BID ADDENDUM NO. 4

Date of Addendum: April 17, 2026
Issued for Bid Date: March 27, 2026
Client Name: Public Schools of the Tarrytowns
Project Name: 2024 Capital Bond Project – Phase 2; Washington Irving Intermediate School
SED Project No.: 66-04-01-03-0-002-017
TUFSD Bid Number: 25/26-TUFSD-003
MEMASI Project No.: 101-2403
Contracts: Contract 1: General Construction (GC)
Contract 2: Mechanical Construction (MC)
Contract 3: Electrical Construction (EC)
Contract 4: Plumbing Construction (PC)

SK-C200-1
 RE: SHEET C200 -
 SITE PREP, DEMO, AND EROSION CONTROL PLAN
 Addendum #4 | Concrete Door Pad

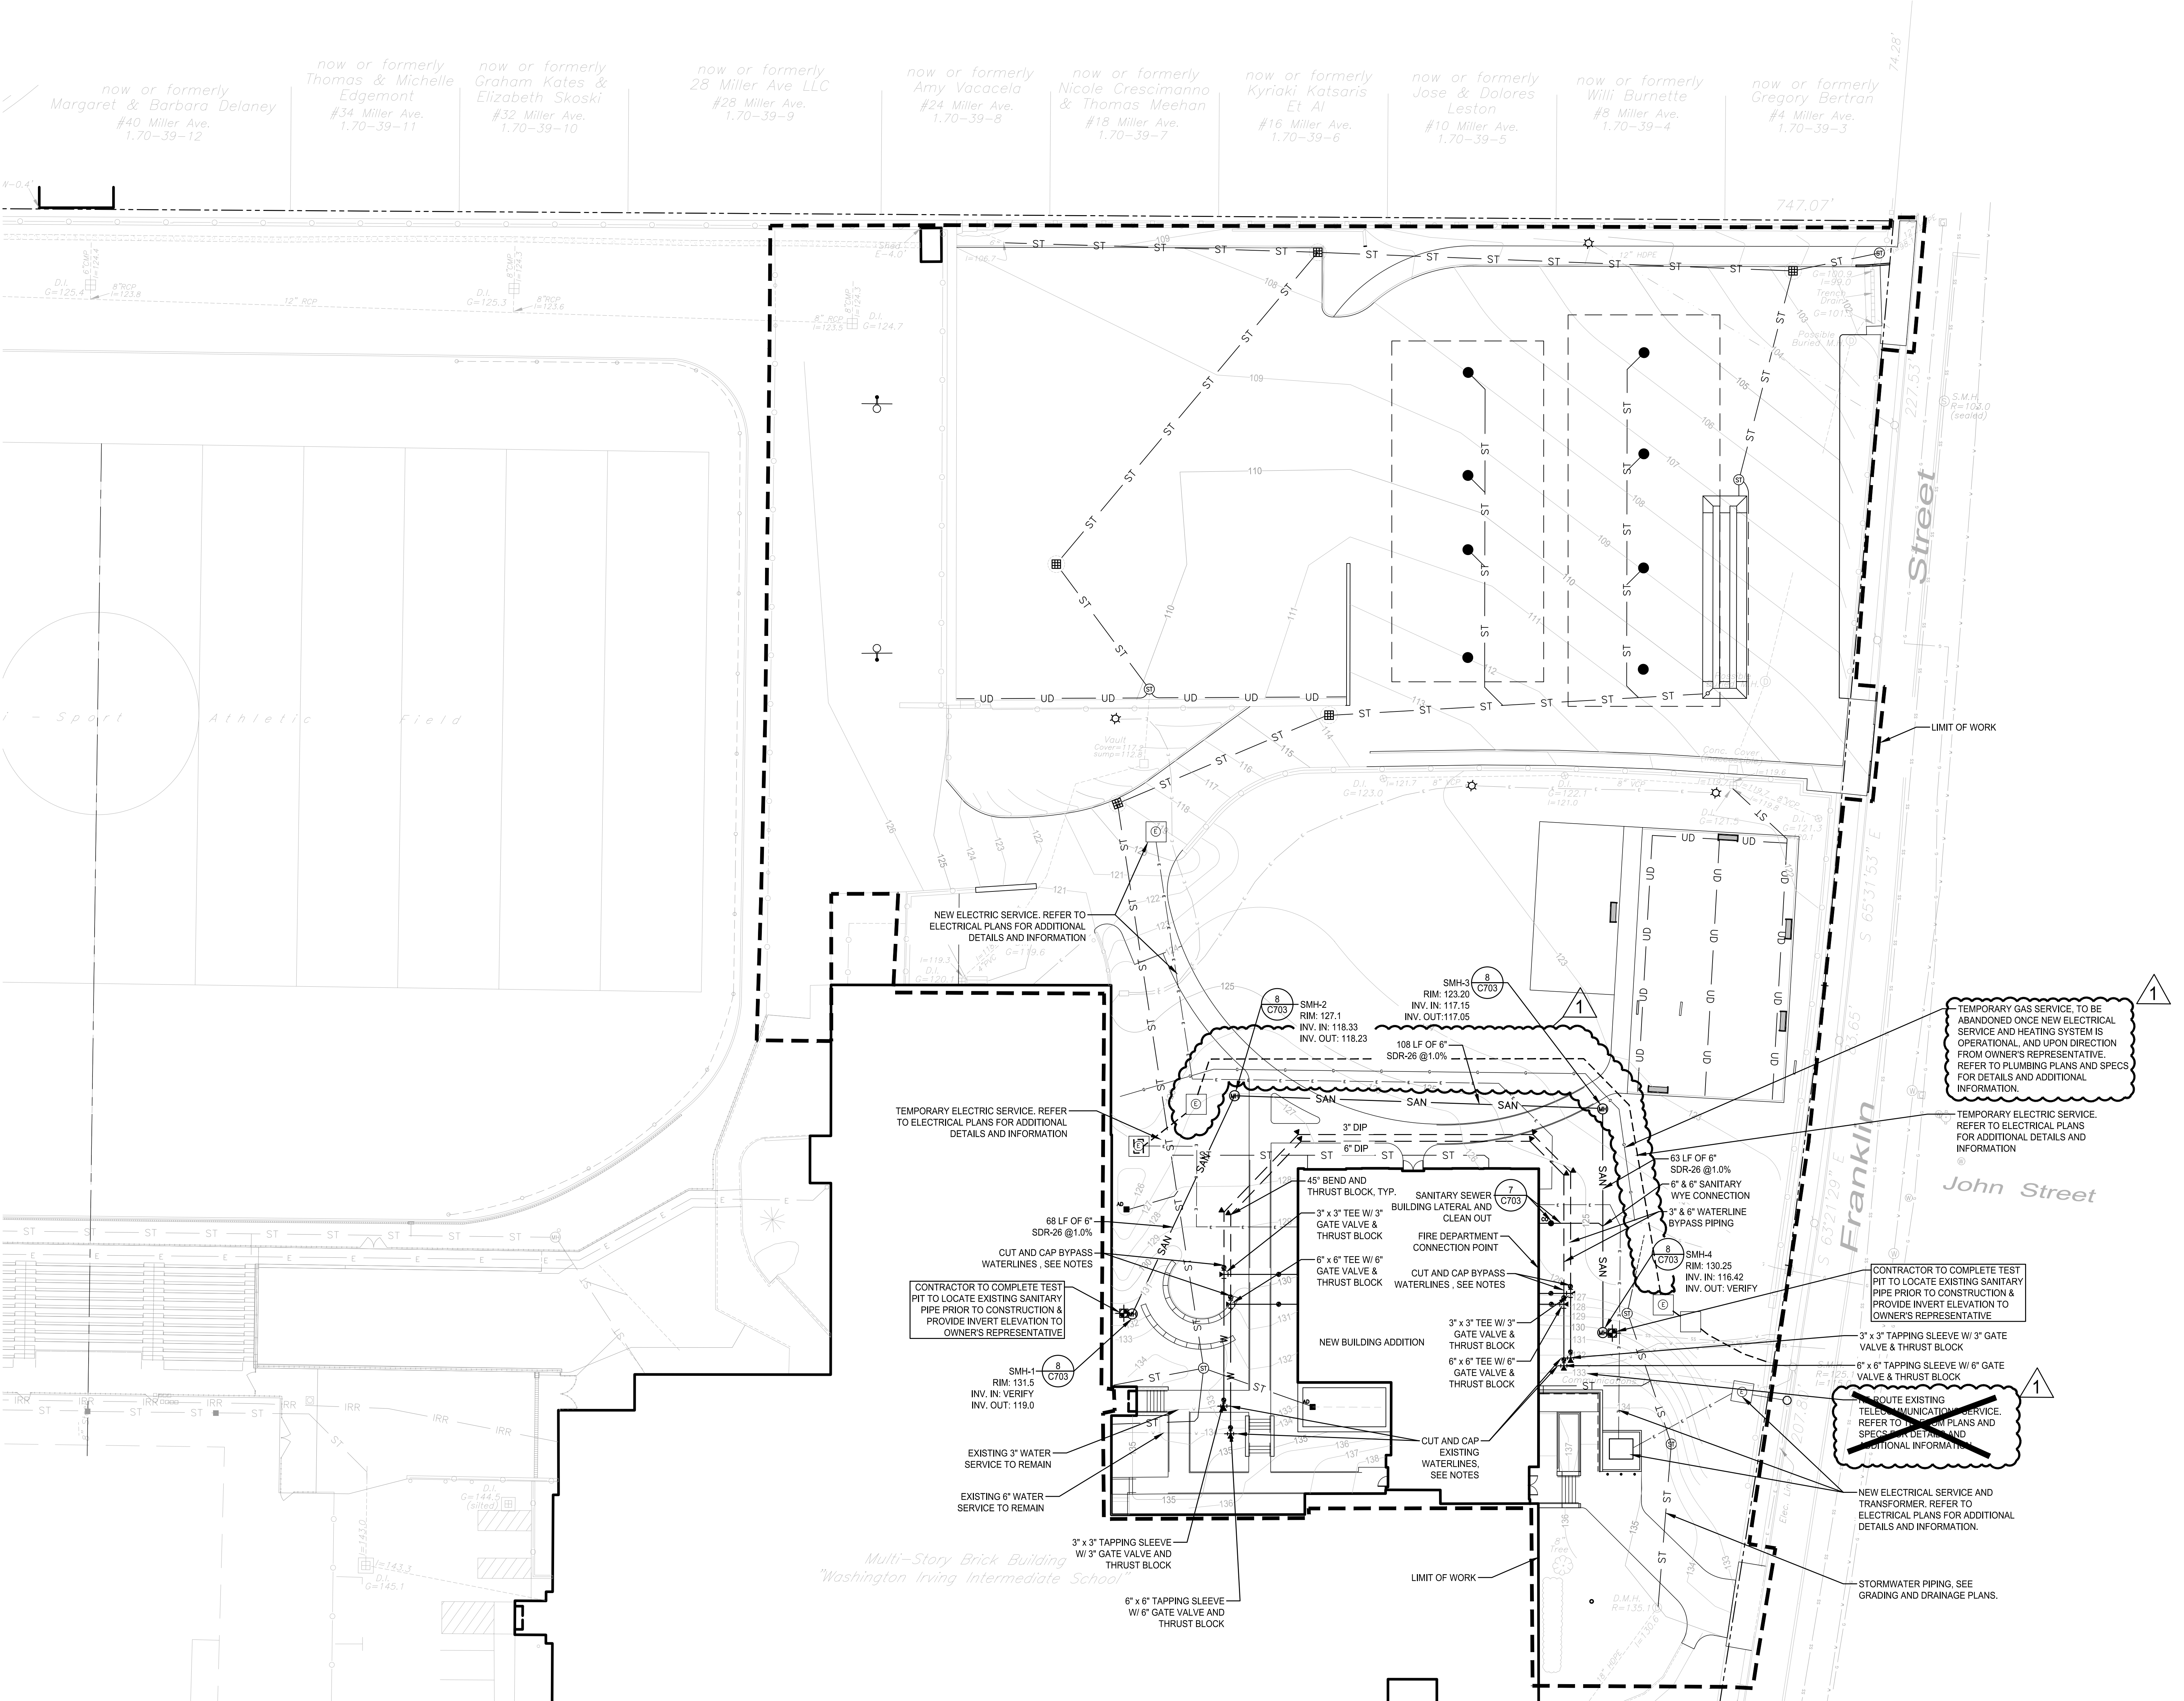
- a. SHEET C100 - SITE PREP, DEMO, AND EROSION CONTROL PLAN; DELETE existing sheet C100. ADD Sheet C100, revised 4/17/2026, attached.
- b. SHEET C200 – SITE LAYOUT PLAN; REVISE concrete landing at Door EXT-Q in accordance with Sketch SK-C200-1, attached.
- c. SHEET C500 – SITE LAYOUT PLAN; DELETE existing sheet C500. ADD Sheet C500, revised 4/17/2026, attached.
- d. SHEET AD101-B – DEMOLITION PART– GROUND FLOOR AREA B; DELETE existing sheet AD101-B. ADD Sheet AD101-B, revised 4/17/2026, attached.
- e. SHEET A403 – GYMNASIUM INTERIOR ELEVATIONS; ADD acoustic panels in accordance with SHEET A403, revised 4/17/2026, attached.
